UNITED STATES PATENT AND TRADEMARK OFFICE

APPLICATION NO.	FILING DATE	FIRST NAMED INVENTOR	ATTORNEY DOCKET NO.	CONFIRMATION NO.
10/780,512	02/17/2004	Tai-Chun Huang	TS03-461	1383
42717	7590	04/06/2005	EXAMINER	
HAYNES AND BOONE, LLP 901 MAIN STREET, SUITE 3100 DALLAS, TX 75202			CHU, CHRIS C	
			ART UNIT	PAPER NUMBER
			2815

Office Action Summary

DETAILED ACTION

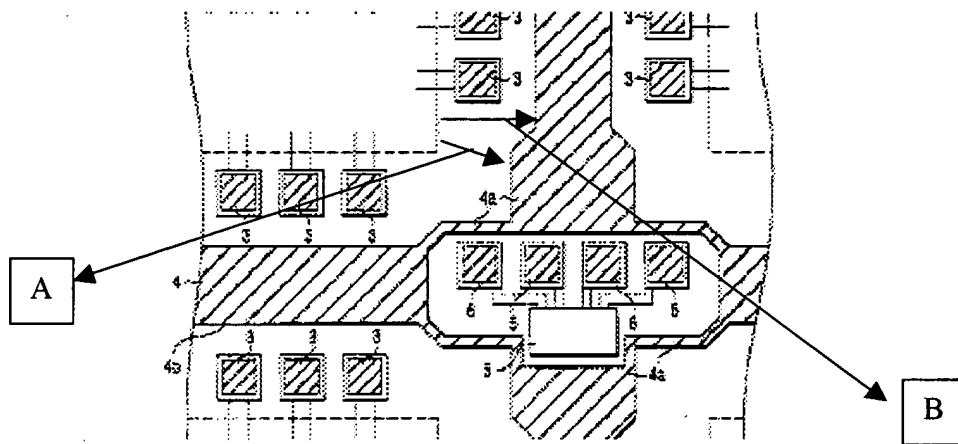
Regarding claim 16, Tsuji et al. discloses in Figure and column 2, lines 45 – 67 a semiconductor device (1; column 2, line 46) comprising:

- semiconductor device structures (any structures inside of the element 4) formed in and on a substrate; and
- a seal ring (4; column 1, line 58 – 60 and Figure show corners and sides of four chips that are separated by the lines 4. Thus, the lines 4 that cover the every corners and

- sides of a single chip's board lines read as a continuous seal ring.) enclosing said semiconductor device structures forming a single die (2; column 2, line 51),
- wherein a first distance (A) between said semiconductor device structures and a corner portion of said seal ring is smaller than a second distance (B) between said semiconductor device structures and an edge portion of said seal ring (see Figure below).

Regarding claim 21, Tsuji et al. discloses in Figure said corner portion (4a; column 2, line 54) of said seal ring (4) having a first width and wherein said edge portion (4b; column 2, line

55) of said seal ring has a second width wherein said first width is wider than said second width (see Figure and column 2, lines 54 – 56).

Regarding claim 22, Tsuji et al. discloses in Figure said first width being “about” 1.5 times said second width or greater (column 2, lines 61 – 63).

Regarding claim 23, Tsuji et al. discloses in Figure said first width of said seal ring covering a portion of said corner portion of said seal ring (see the Figure).

Regarding claim 25, Tsuji et al. discloses in Figure one or more slots or holes (at the area where the elements 5 and 6 are formed) being formed in said corner portion (4a) of said seal ring (4).
